AGENDA

March 18, 2014

**Town of Milford
Planning Board Minutes
February 18, 2014**

Date: March 18, 2014
To: Town of Milford Planning Board
From: Jodie Levandowski, Town Planner
Subject: **John Samonas/TMC CF of New England LLC – Nashua St – Map 44, Lot 11;**
Major site plan for a proposed retail convenience store and gas sales with associated site improvements. (*Tabled from 2/25/14*)

Sheet 6- Erosion Control Plan

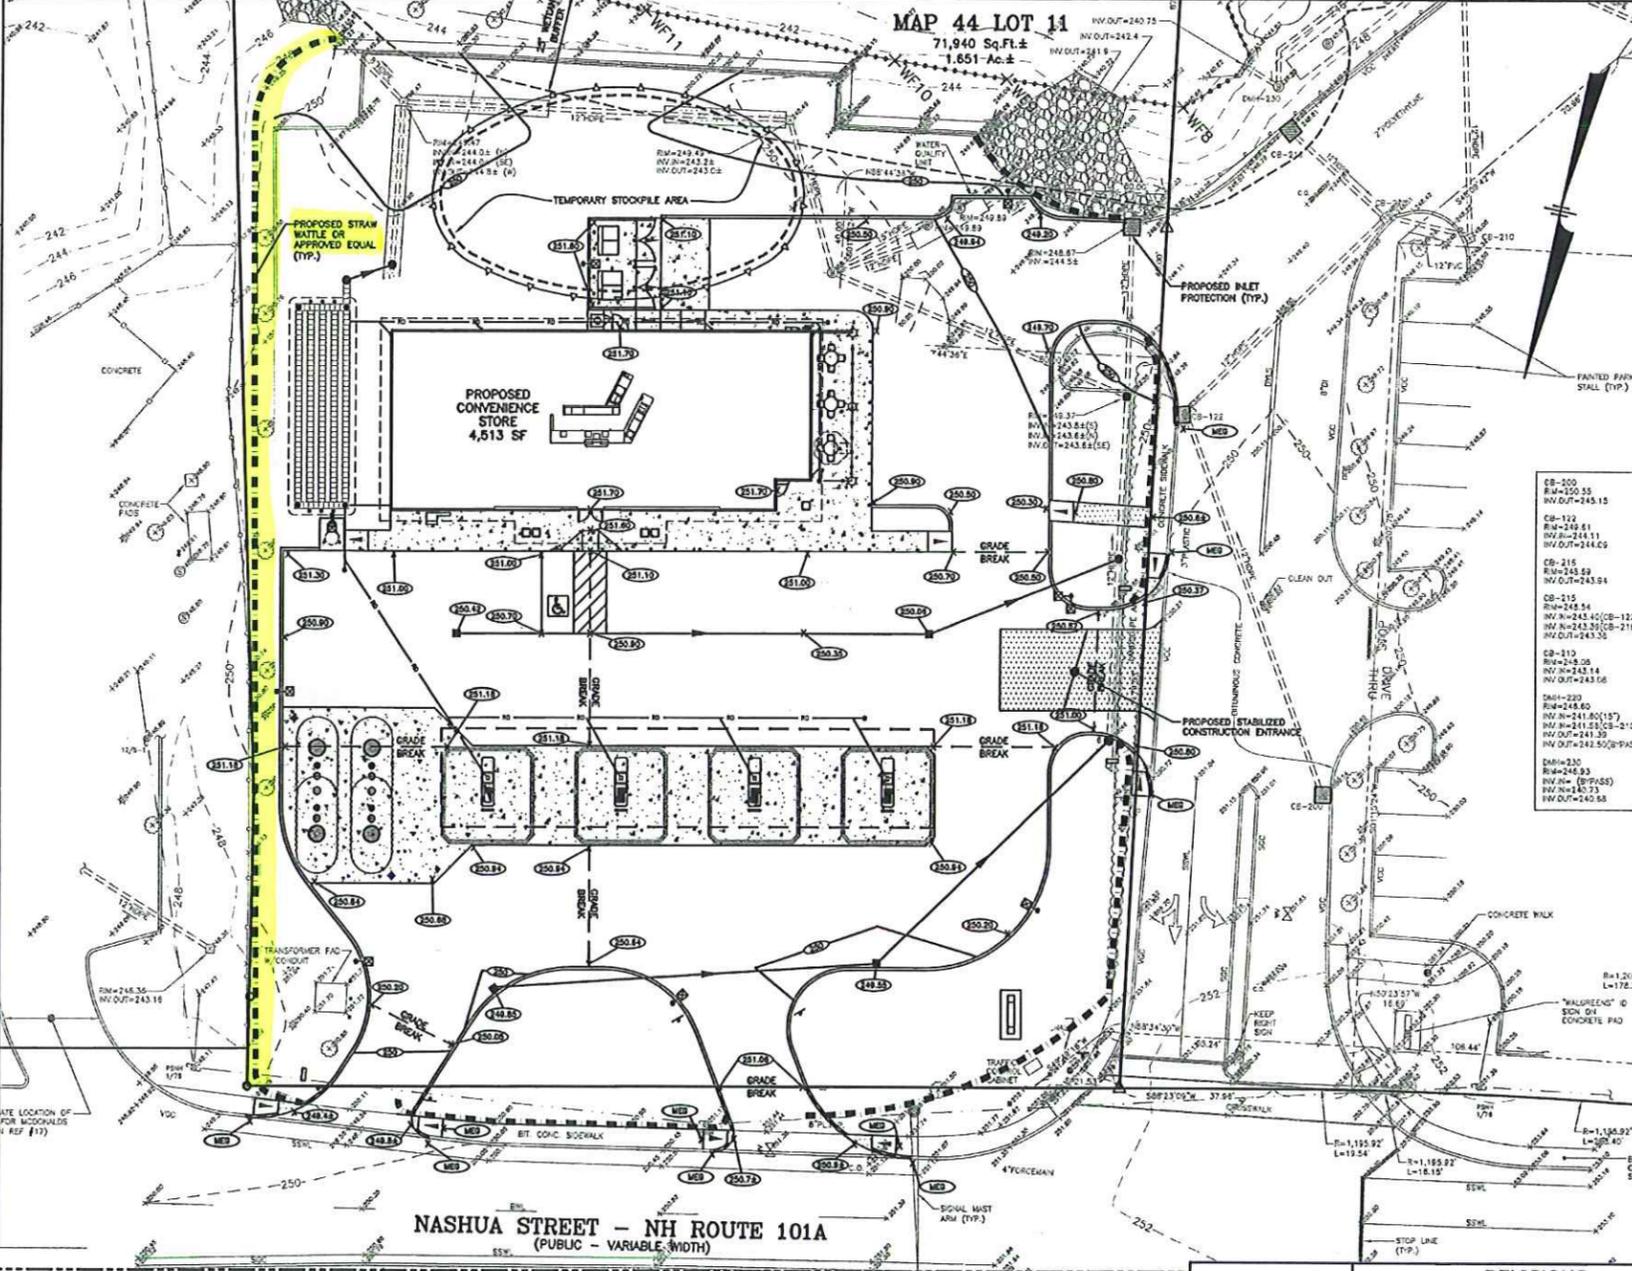
Zoning Administrator:
